Product Notice

Product Family: Pro-Turn 200 & 400 Series Mowers

Subject: ZT-5400 Transaxle

SUBJECT: Improperly Assembled ZT-5400 Bypass

Figure 1

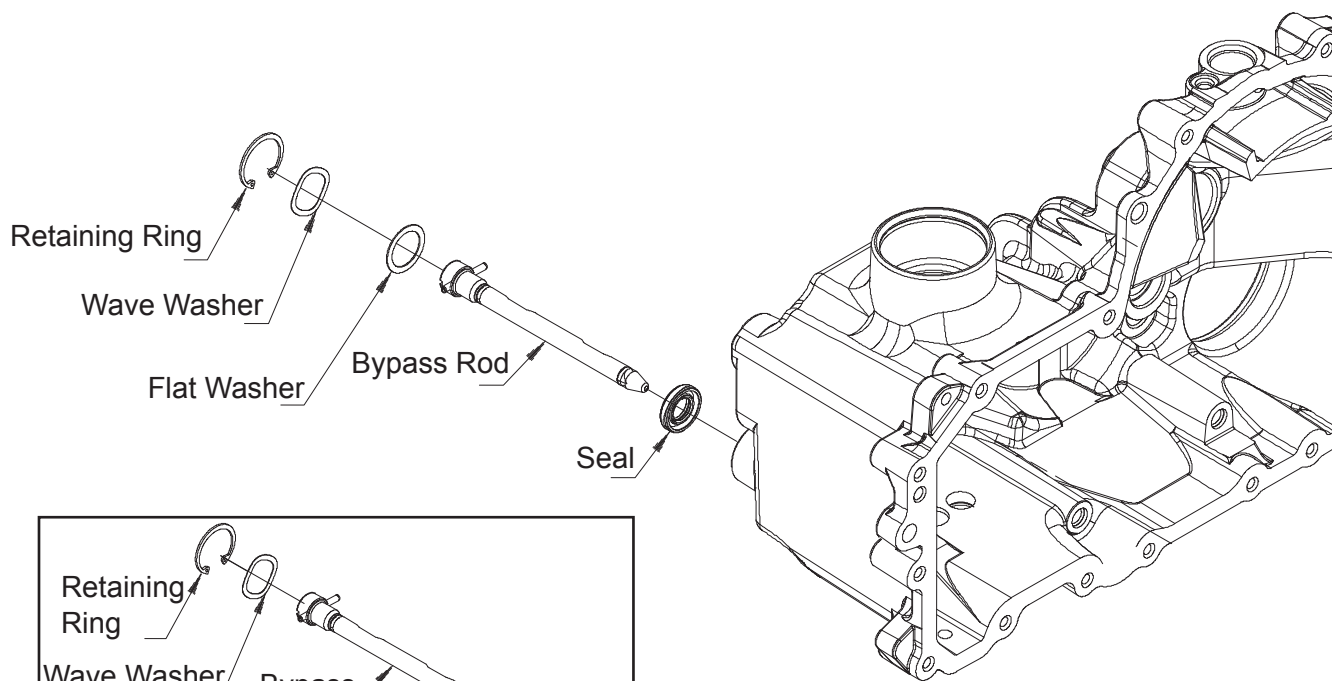
It has come to Hydro-Gear's attention that the bypass on some ZT-5400s may be assembled incorrectly. This can cause the transaxle to malfunction. Inspect the order of the transaxles bypass components. A correctly assembled bypass will have the seal, bypass rod, flat washer, wave washer and retaining ring installed in that order (see Figure 1). For example there have been reports of the bypass assembled incorrectly with the flat washer between the seal and the bypass rod (see Figure 2).

To correct this the retaining ring and wave washer will need to be removed and set aside. In order to keep oil loss to a minimum the bypass rod only needs to be partially removed. This will allow the technician to work the flat washer off the bypass rod. Once the flat washer was been removed the bypass rod can then be installed back into the transaxle. The flat washer, wave washer and retaining ring can then be installed (see Figure 1). Only a small amount of oil should be lost during this procedure. If needed, top off the reservoir.
